SUBJECT: REQUEST FOR ADDITIONAL INFORMATION RE: BOILING WATER
REACTOR OWNERS' GROUP TOPICAL REPORT NEDC-33347P,
REVISION 1, "CONTAINMENT OVERPRESSURE CREDIT FOR NET
POSITIVE SUCTION HEAD (NPSH)" (TAC NO. MF6708)

REQUEST FOR ADDITIONAL INFORMATION

NEDC-33347P, REVISION 1, "CONTAINMENT OVERPRESSURE CREDIT FOR NET POSITIVE

BOILING WATER REACTOR OWNERS' GROUP

FIGURE 1: FLOW CHART FOR LOCA CONTAINMENT AND NPSH ANALYSES

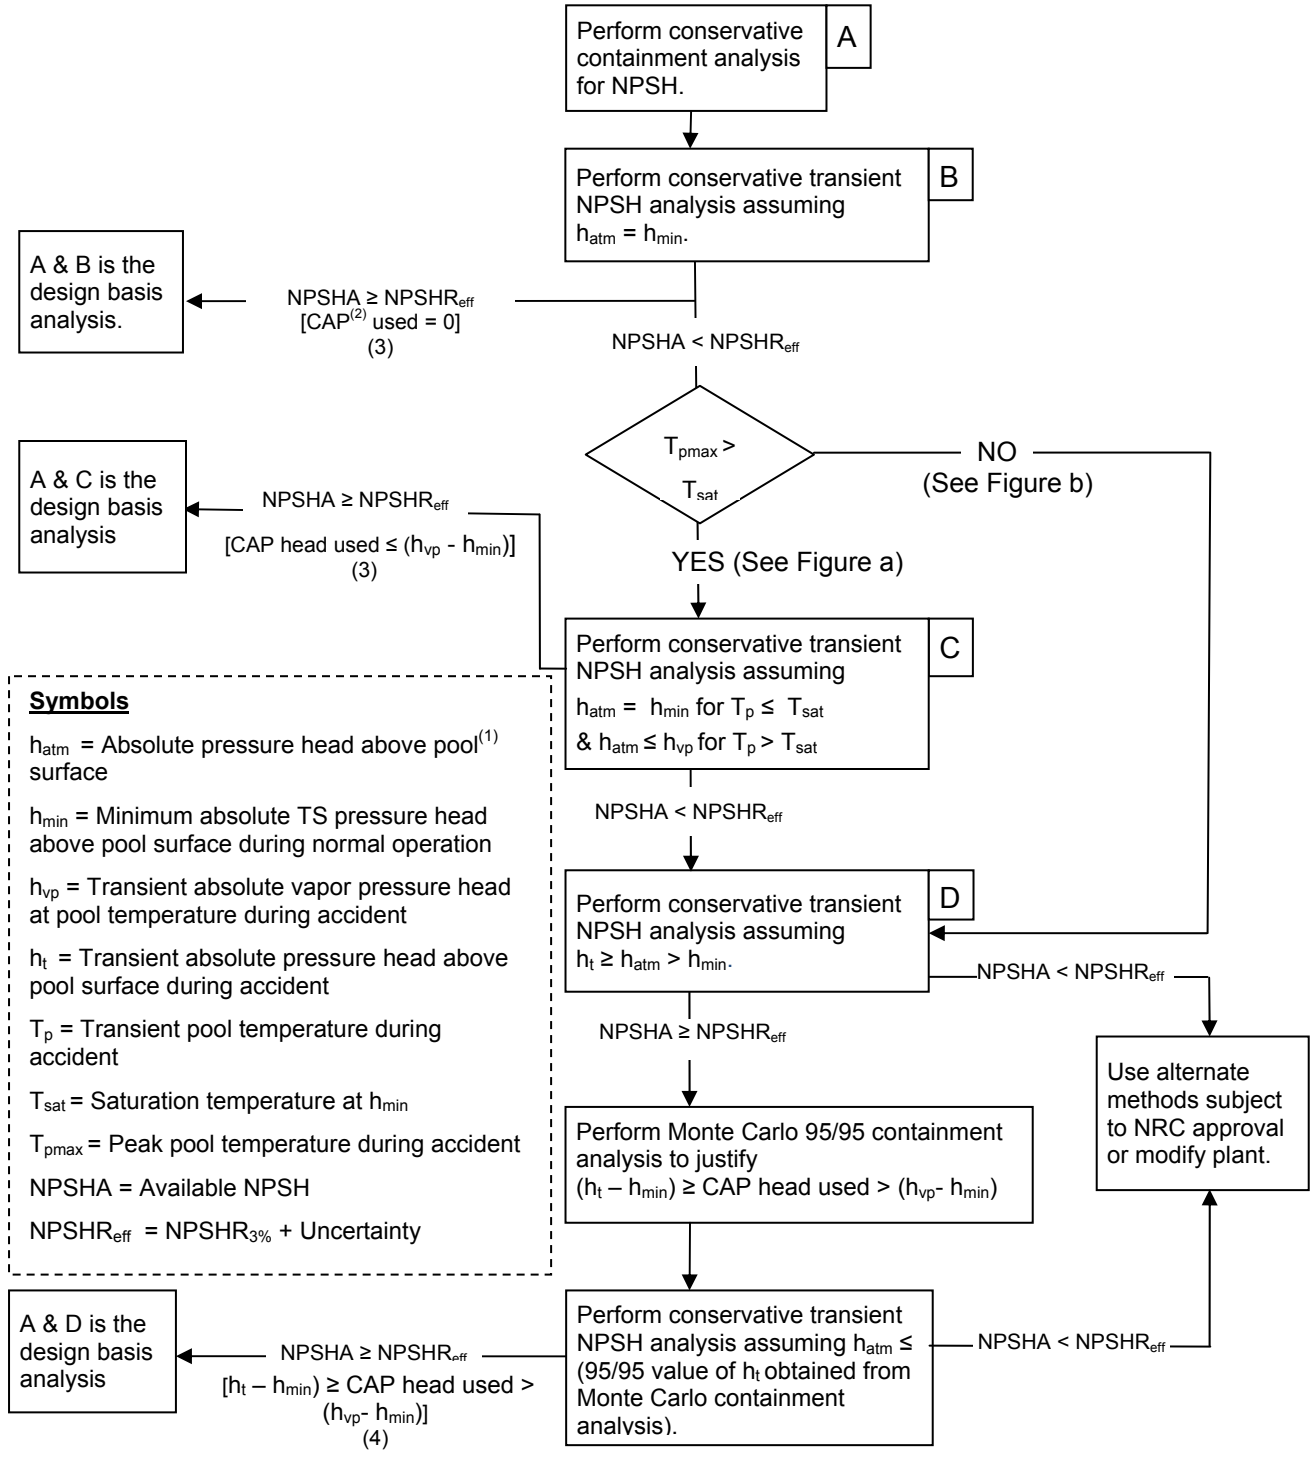
2. The revised draft safety evaluation report (SER) sent by letter dated March 10, 2010 (Reference 3), was issued after the NRC staff resolved the Boiling Water Reactor Owners' Group (BWROG) comments on the draft SER transmitted by letter dated September 29, 2009 (Reference 2). The Figure 2, "Flow Diagram for Deterministic and Statistical Containment Analysis Approved by the NRC staff," in the revised draft SER (Reference 3), has been modified and will be replaced in the final SER with Figures 1, a, and b, as enclosed, which define the containment analysis licensing bases for use of containment accident pressure approved by the NRC staff. These Figures are the same as those provided to the BWROG in letter dated February 25, 2013 (Reference 7). Please provide your comment on factual errors or clarity concerns contained in these Figures.
